**COUNCIL ASSESSMENT PANEL MEETING**  
**10 April 2019**  
**AGENDA – 8.1**

<b>Applicant:</b> Nikolas Carsiotis	<b>Landowner:</b> P D Hannon
<b>Agent:</b> Garth Heynen	<b>Originating Officer:</b> Doug Samardzija
<b>Development Application:</b>	18/760/473
<b>Application Description:</b> Two storey mixed use development incorporating shop, office, residential flat building (8 dwellings), undercroft car parking, retaining walls (maximum height 1.2m), fence (maximum height 3.4m), associated landscaping & earthworks, & demolition of existing dwelling & outbuildings	
<b>Subject Land:</b> Lot:13 Sec: P53 FP:158259 CT:5350/901	<b>General Location:</b> 14 Johnston Street Stirling  <i>Attachment – Locality Plan</i>
<b>Development Plan Consolidated :</b> 24 October 2017 <b>Map</b> AdHi/1, 28 & 72	<b>Zone/Policy Area:</b> District Centre Zone & Stirling Core Policy Area
<b>Form of Development:</b> Merit	<b>Site Area:</b> 1052m <sup>2</sup>
<b>Public Notice Category:</b> Category 2 Merit	<b>Representations Received:</b> 4  <b>Representations to be Heard:</b> 3

The purpose of this application is for a two storey mixed use development incorporating a shop, office and residential flat building (

**EFFECT OF LOWERING THE PROPOSED DEVELOPMENT 255MM BELOW WHAT IS PROPOSED  
 OVERLOOKING OCCURS  
 ILLUSTRATION SHOWS 1.5M AND 1.8M FENCE**

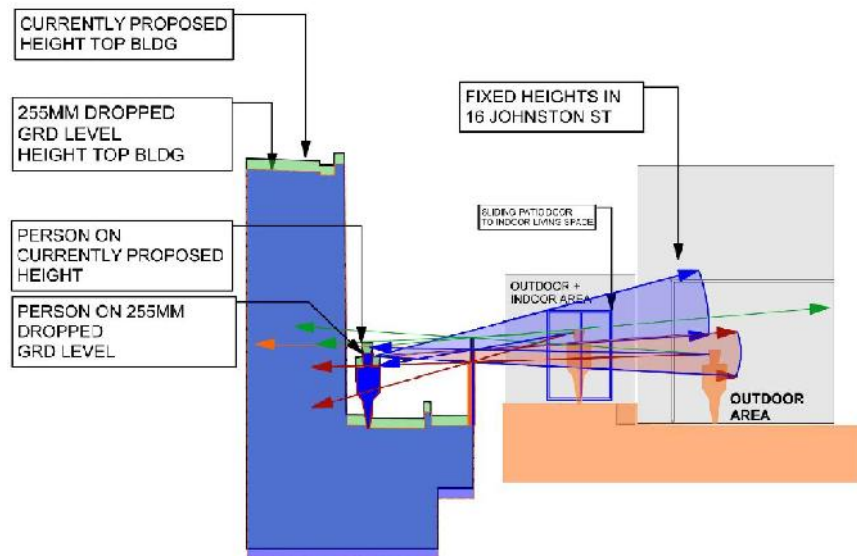
Immediate neighbours to the south at 16 Johnston Street have raised concerns in their representation in relation to the bulk and scale, overshadowing and overlooking. The first 18m approximately of the southern property boundary is not changing with the existing fence remaining and providing the necessary privacy and separation between the properties. However from the 18m point the land slopes away to the rear and the height of the fence tapers with the slope of the land. As such from this point the proposal includes a 1.8m high privacy screen proposed adjacent and above the existing fence. The image below with the green shading indicates the existing fence and the red indicates the new privacy screen proposed as part of the development:

This privacy screen is also depicted on the perspective image identified as drawing number DA.18. At the highest point toward the rear of 16 Johnston Street this privacy screen will be 3.1m in height from ground level, with the height dropping to 2.9m along the rear allotment boundary of 29 Milan Terrace. Relevant Objectives and PDCs seek that buildings are designed to minimise their visual impact, prevent the loss of sunlight or views, enhance the attractiveness of the development and be compatible with existing development. In the context of the side boundary treatment with privacy screens above the existing fence lines, the proposed development fails to comply with these Objectives and PDCs. The applicant was asked if the level of the building could be lowered further which would in effect reduce the total height of the privacy screen and therefore minimise the impact of the structure when viewed from adjoining properties. The response from the applicant was that further lowering of the structure would create a number of issues including placing constraints on the future development of 12 Johnston Street due to the deeper excavations on the development site. Further, it would create overlooking potential from 16 Johnston Street into the proposed residential units as shown in the illustration below. However, the main concern with the lowering of the building is the issues that this would create with increased gradient of vehicle and pedestrian ramps. In effect lowering the floor level would minimise the undercarriage clearance for vehicles entering the car park.

Council acknowledges that the proposed privacy screen fails to meet the relevant Objective of the Development Plan which talks about minimising the bulk and scale of the development and protecting the amenity of the locality. However, regard must be given to the restriction posed by the narrow site, the need to ensure that vehicle and pedestrian ramps are of an appropriate standard to allow for safe and practical use and the need for the screens to be installed to protect the privacy of the adjoining properties. The impact of the structure on 29 Milan Terrace is considered to be minimal given the separation distance between the back fence and the dwelling on that site, and that a large portion of the structure is going to remain well screened by the existing tree which will be retained through use of alternative footing design. The impact on 16 Johnston Street is much greater given that the screen will be directly visible from the dwelling's private open space. However, it should be noted that the screen is going to be installed within the subject land and detached from the existing fence. This will allow for the structure to be softened with climber plants to minimise the visual impact to the dwelling at 16 Johnston Street.

Figure 1 - Extract for the Council's Development Plan

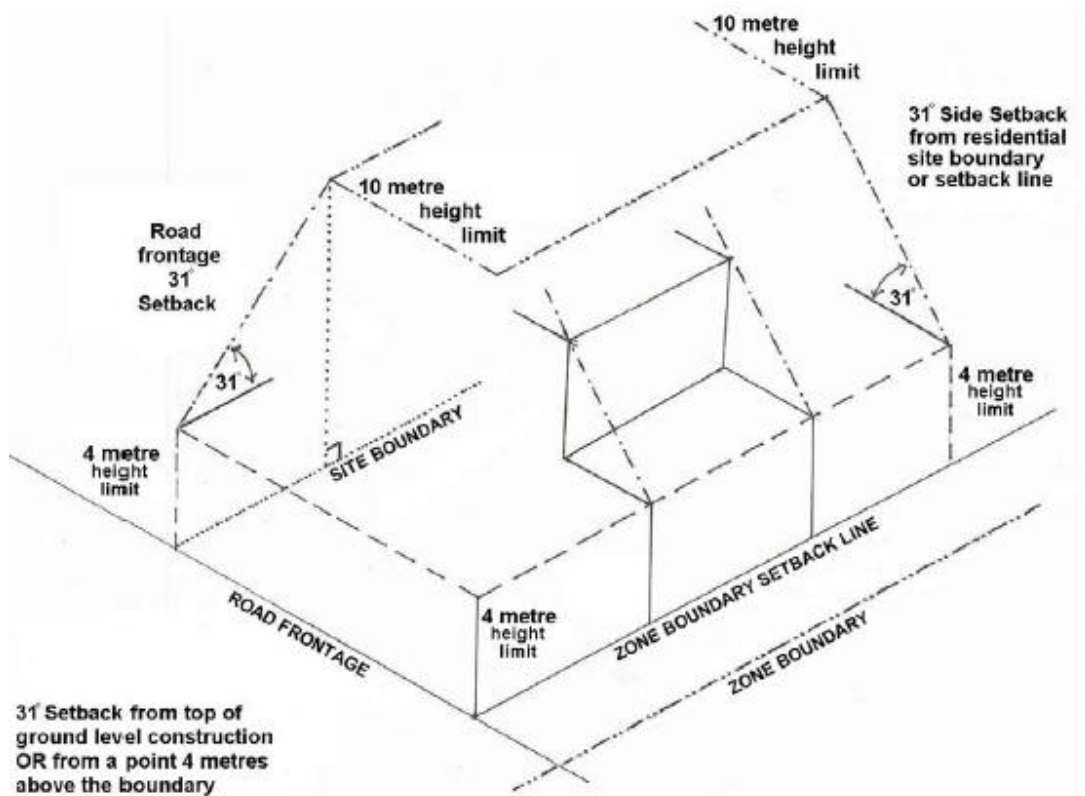
PDC 7 of the Stirling Core Policy Area states that no part of the building within the policy should exceed two storeys excluding undercroft parking or 10 metres in height above natural ground level measured at any point on the immediate adjoining site boundary (refer Figure SDC/A below). Drawing number DA.07.01 and drawing number DA.09 provides details of how the proposed development fits within this 10 metre height limit as illustrated in the Figure 1 below. The drawings show interval markers along the two side boundaries from which point the 10 metre measurements were

taken to illustrate the compliance with the 10 metre height restriction. The drawings illustrate that along both side boundaries and through the site at various points (four sections) the development is well within the 10m height restriction. The proposed development thus satisfies the requirements set out in PDC 7 as demonstrated in drawings DA.07.01 and cross section drawings DA.09.
